Public Comments Received on EPA's Draft National Pollutant Discharge Elimination System (NPDES) Permits for Federal Hydroelectric Projects in the Lower Columbia and Snake Rivers

January 15 through February 16, 2021

March 1, 2021

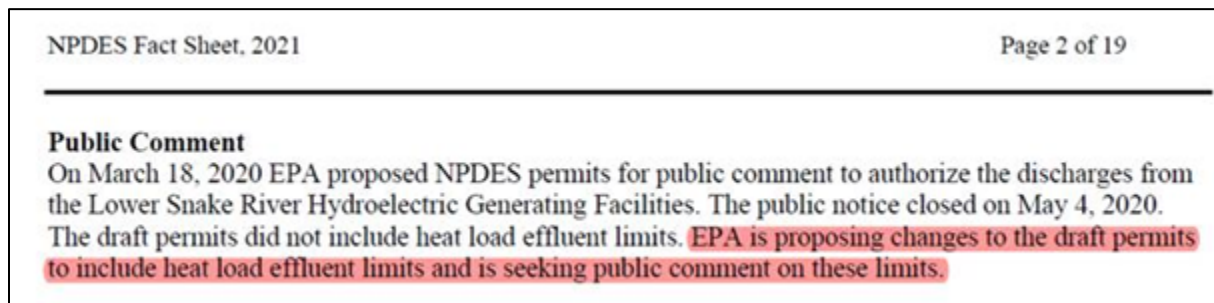
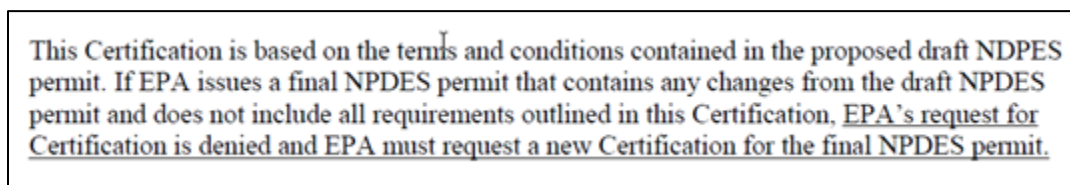
The proposed changes to the draft NPDES permits are changes that trigger the requirement for new 401 water quality certifications. EPA must request new certifications from the WDOE prior to issuing the final NPDES permits.

Based on the language in EPA’s 2021 draft NPDES permits fact sheet, the language states that “EPA is proposing changes to the draft permits”. The exact language is excerpted here:

WDOE’s 401 Certifications for these facilities issued on 7 May 2020, stated that “any changes from the draft NPDES permit” require a new 401 Certification. The exact language is excerpted here:

The language above supports the conclusion that due to substantive changes to the permits, new 401 water quality certifications from WDOE are required.
